MARK	DATE	DESCRIPTIONS	BY	CH'D	CCO#
1	04/02/07	CROSSBEAM KINK	GB	DT	38

SAN FRANCISCO OAKLAND BAY BRIDGE
EAST SPAN SEISMIC SAFETY PROJECT
SELF-ANCHORED SUSPENSION BRIDGE
(SUPERSTRUCTURE & TOWER)

TYPICAL GIRDER DETAILS NO. 15

TYPICAL CROSSBEAM DETAILS NO. 5

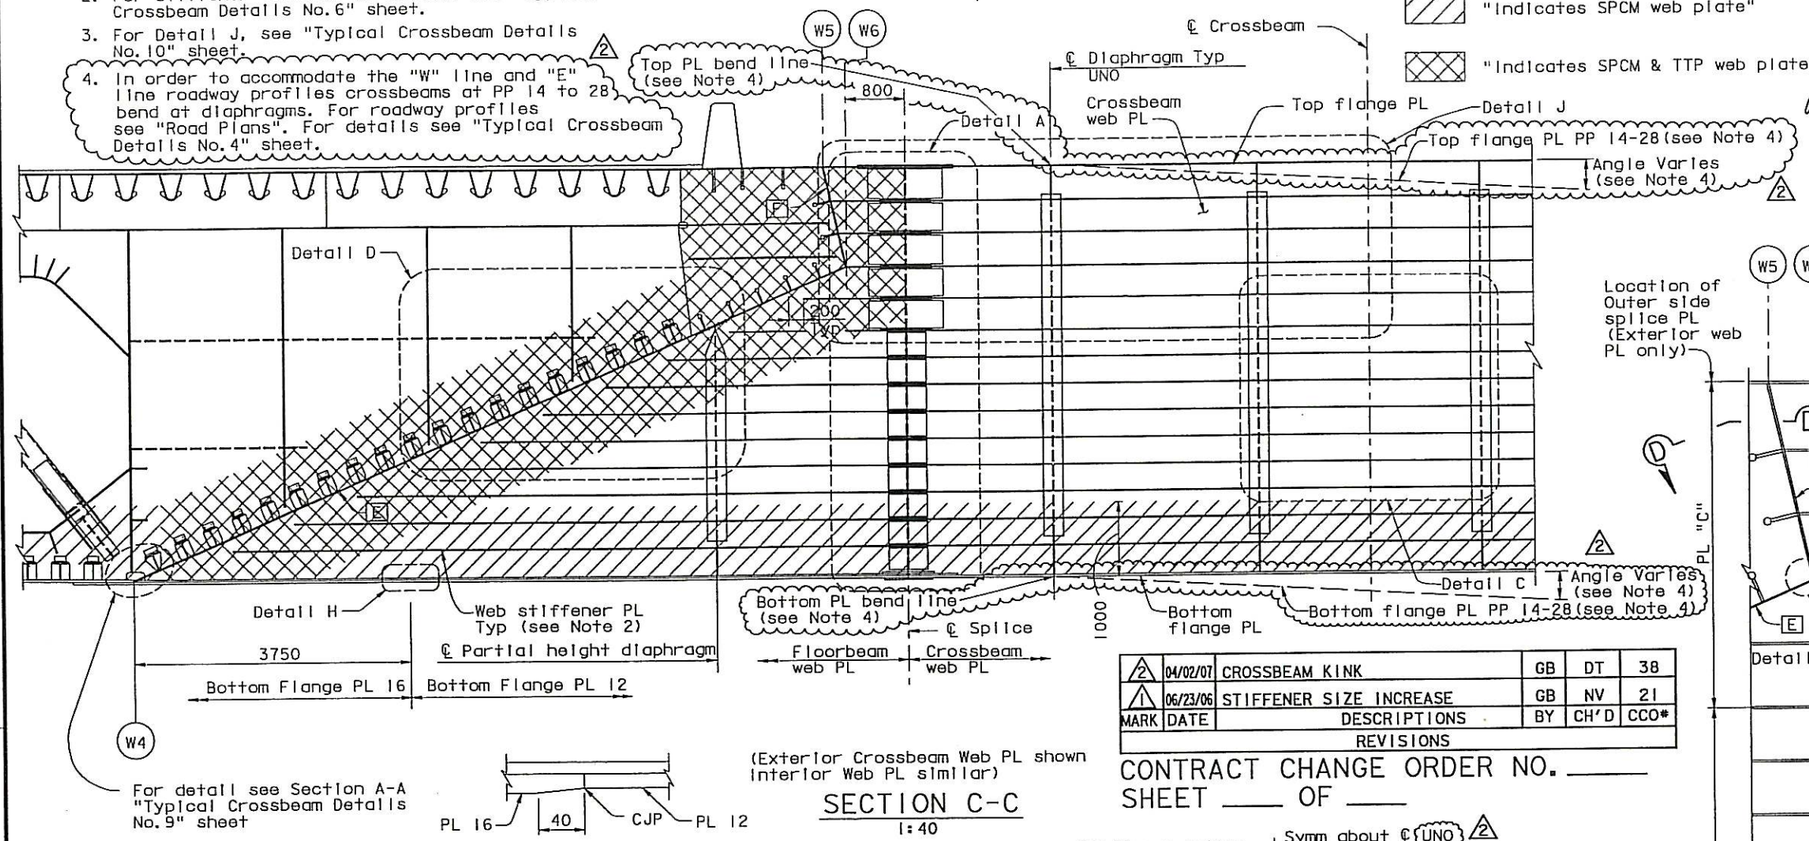
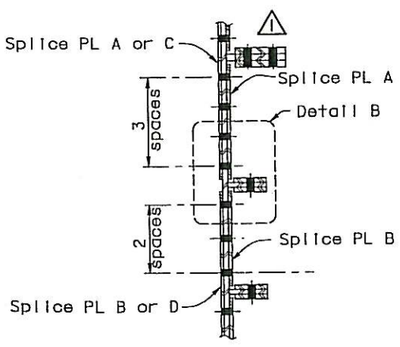
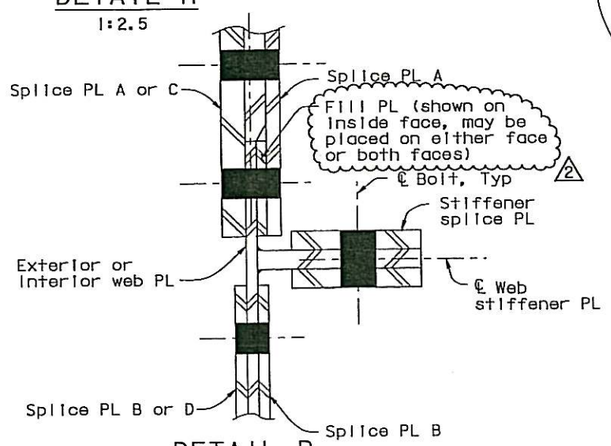
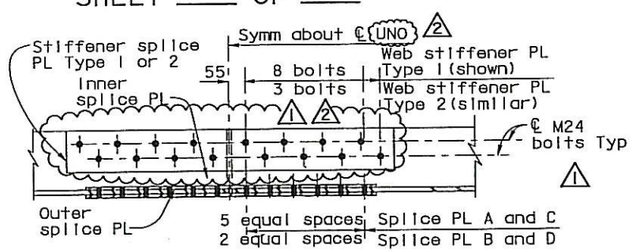
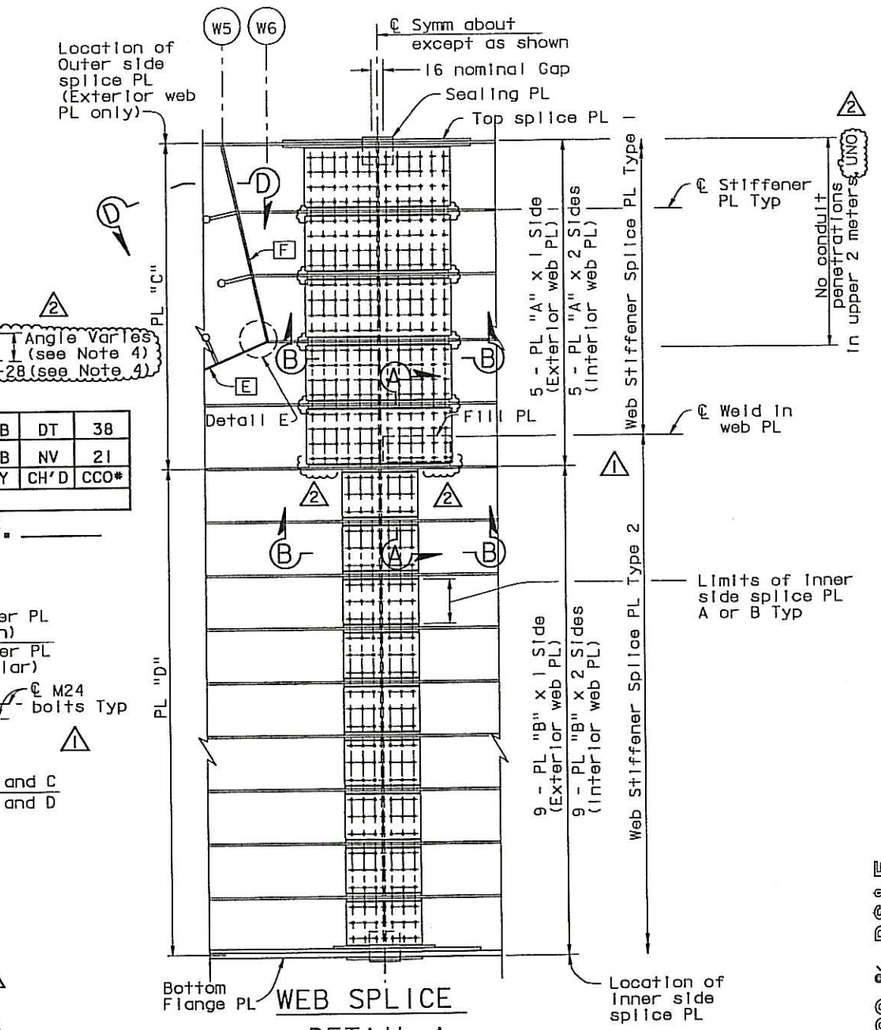
NOTES:
1. For Details C, D and E, and Section D-D, see "Typical Crossbeam Details No. 6" sheet.
2. For stiffener termination detail, see "Typical Crossbeam Details No. 6" sheet.
3. For Detail J, see "Typical Crossbeam Details No. 10" sheet.
4. In order to accommodate the "W" line and "E" line roadway profiles crossbeams at PP 14 to 28 bend at diaphragms. For roadway profiles see "Road Plans". For details see "Typical Crossbeam Details No. 4" sheet.

MARK	DATE	DESCRIPTIONS	BY	CH'D	CCO#
2	04/02/07	CROSSBEAM KINK	GB	DT	38
1	06/23/06	STIFFENER SIZE INCREASE	GB	NV	21

TYPICAL CROSSBEAM DETAILS NO. 6

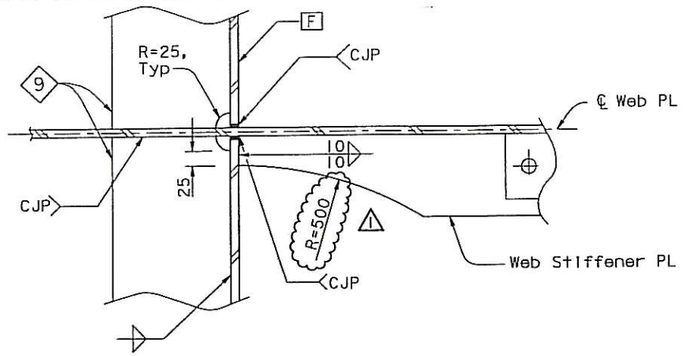
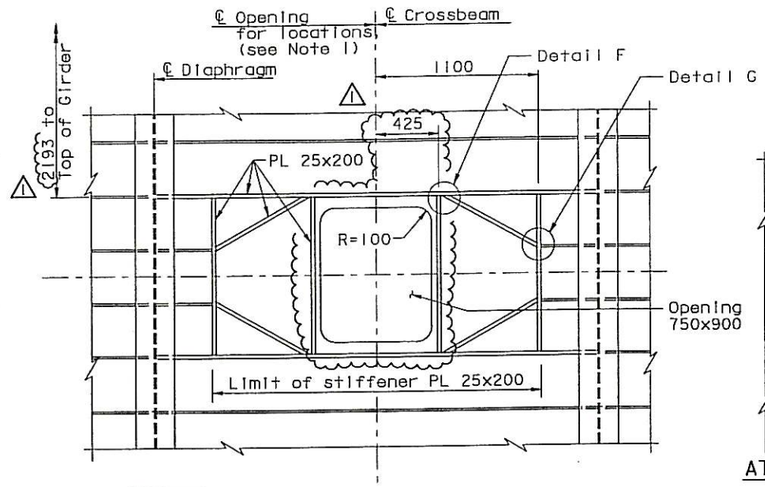
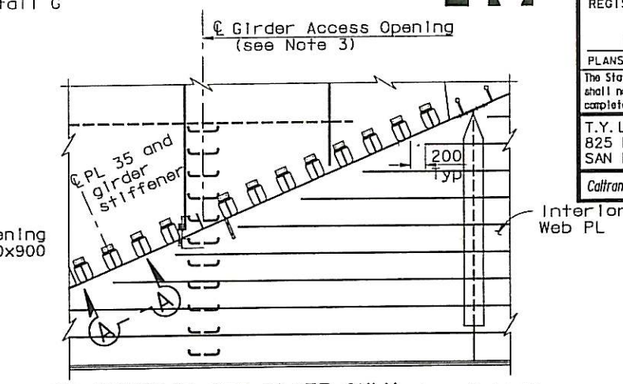
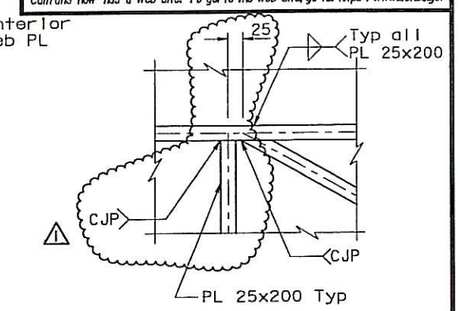
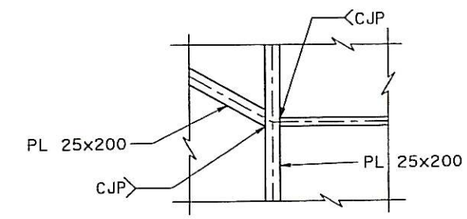
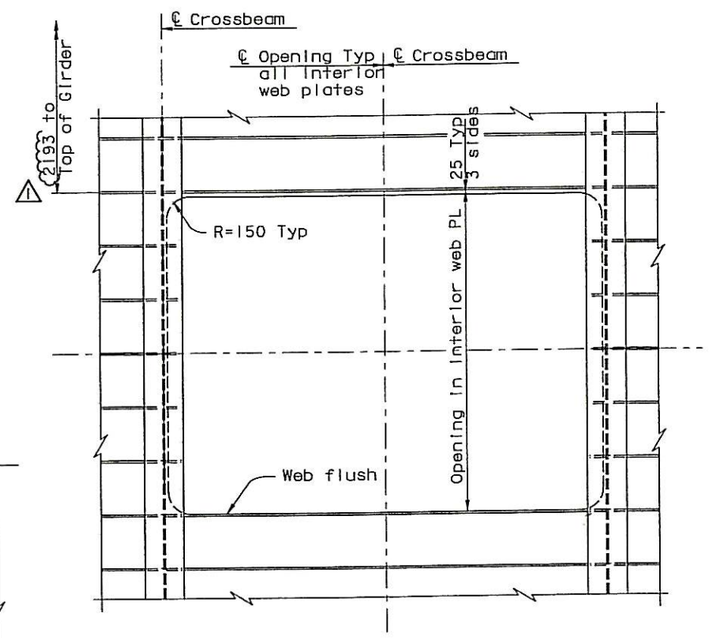
MARK	DATE	DESCRIPTIONS	BY	CH'D	CCO#
1	04/02/07	CROSSBEAM KINK	GB	DT	38

CROSSBEAM AT EAST ANCHORAGE NO. 2

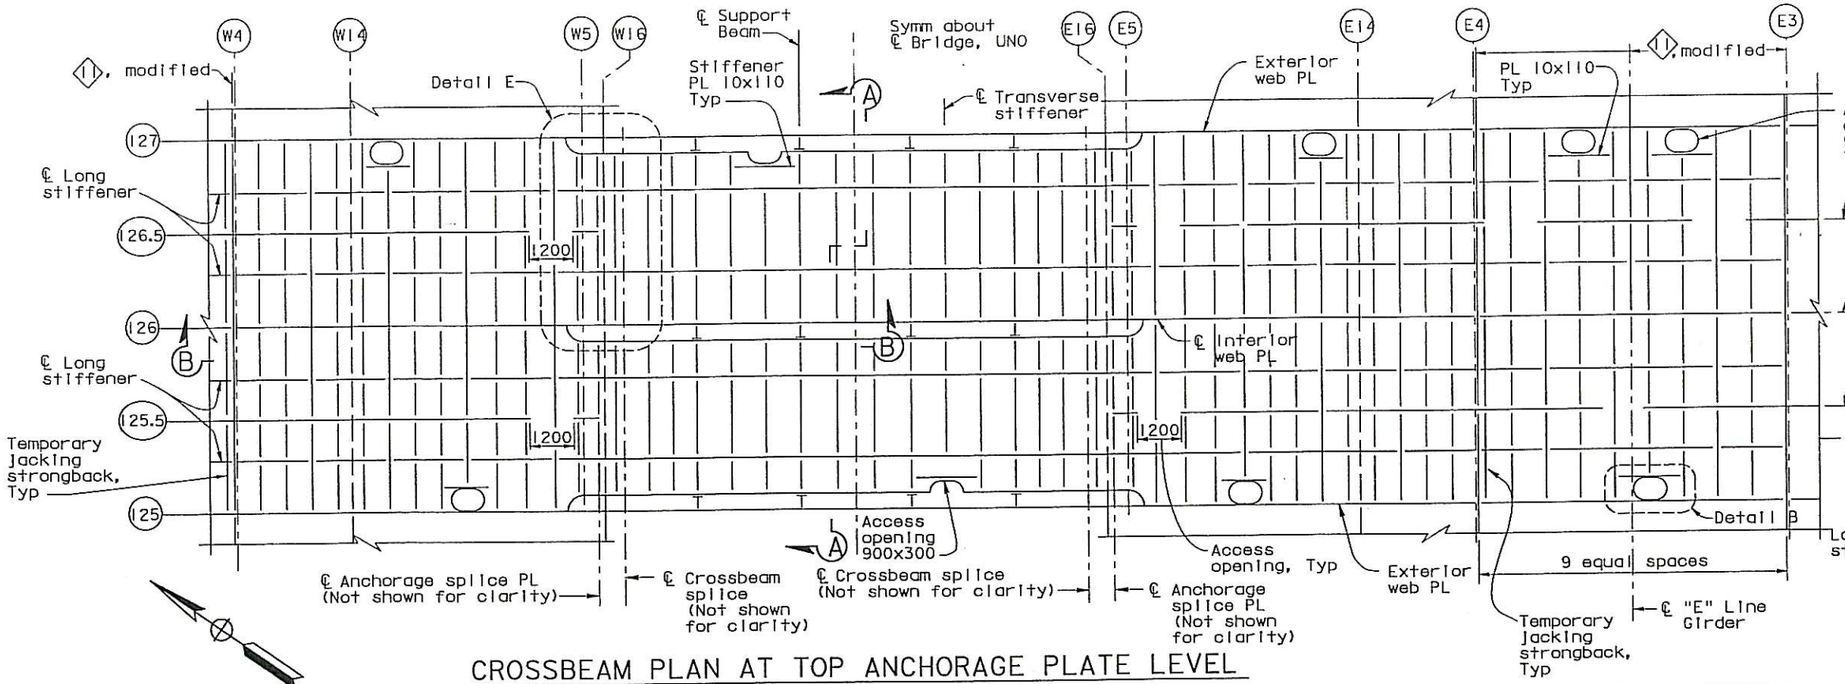
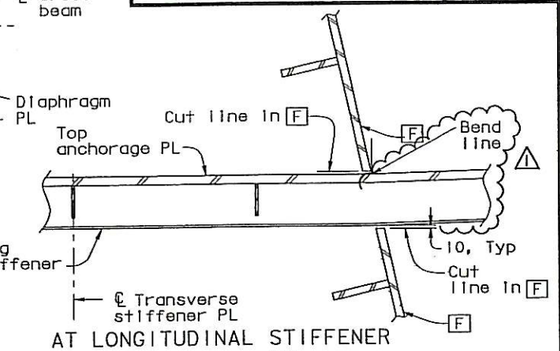
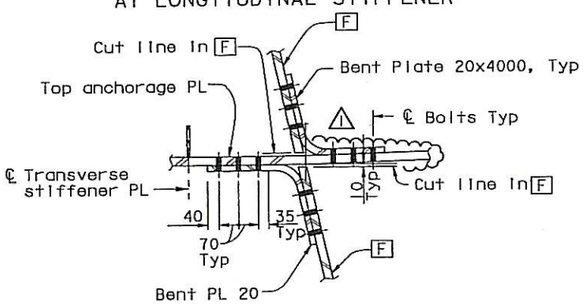
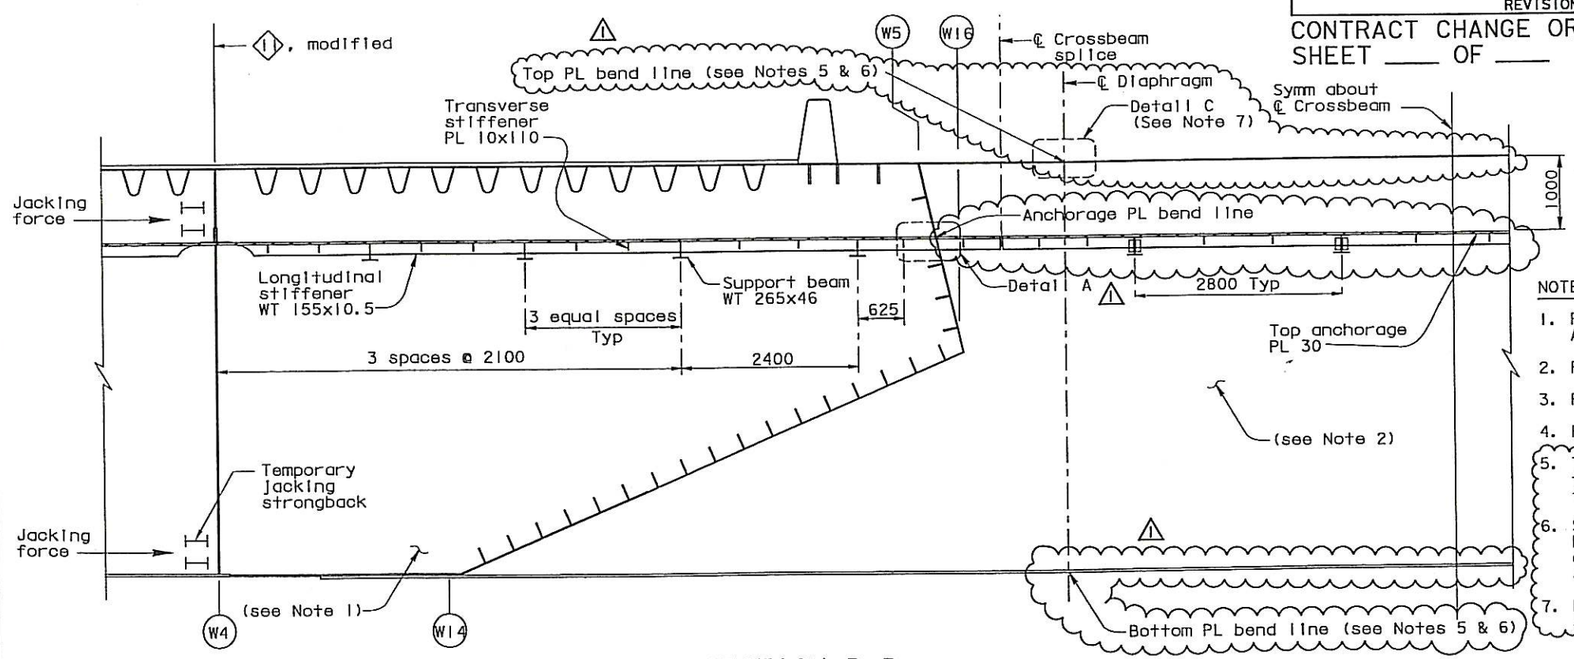
MARK	DATE	DESCRIPTIONS	BY	CH'D	CCO#
1	04/02/07	CROSSBEAM KINK	GB	DT	38

CROSSBEAM AT EAST ANCHORAGE NO. 3

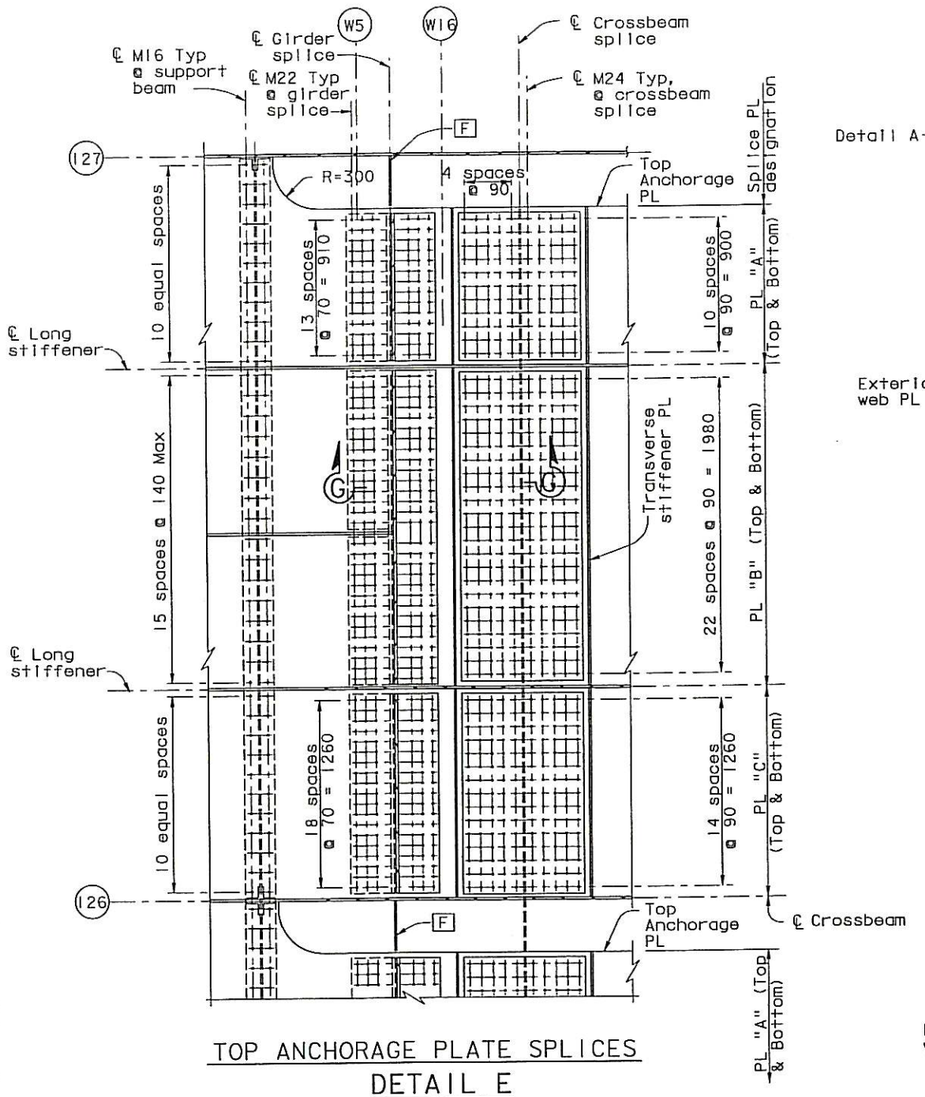
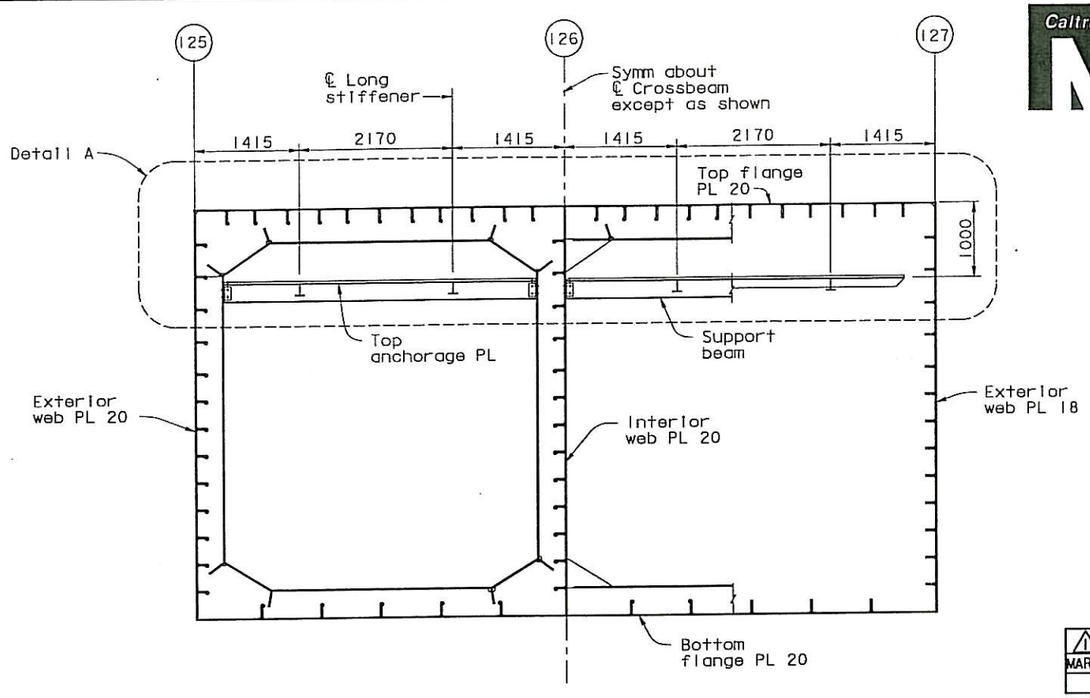
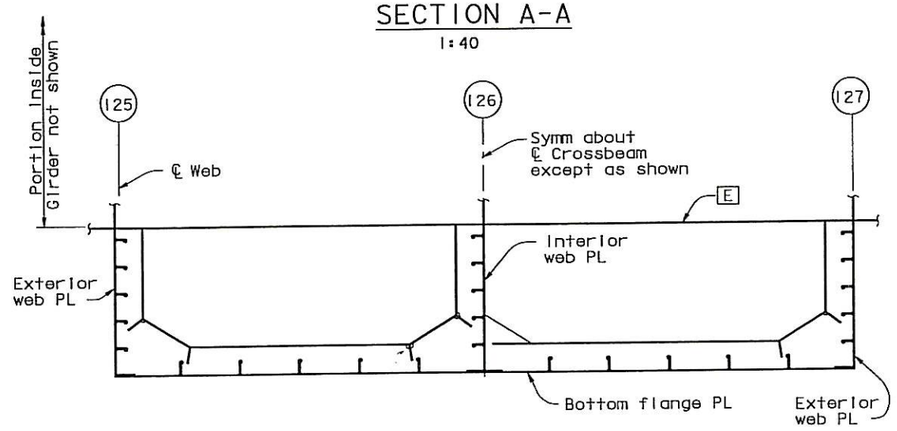
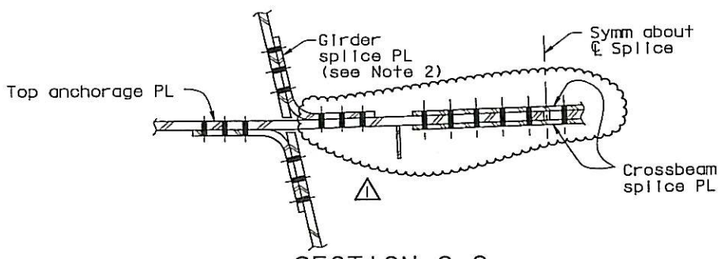
MARK	DATE	DESCRIPTIONS	BY	CH'D	CCO#
1	04/02/07	CROSSBEAM KINK	GB	DT	38
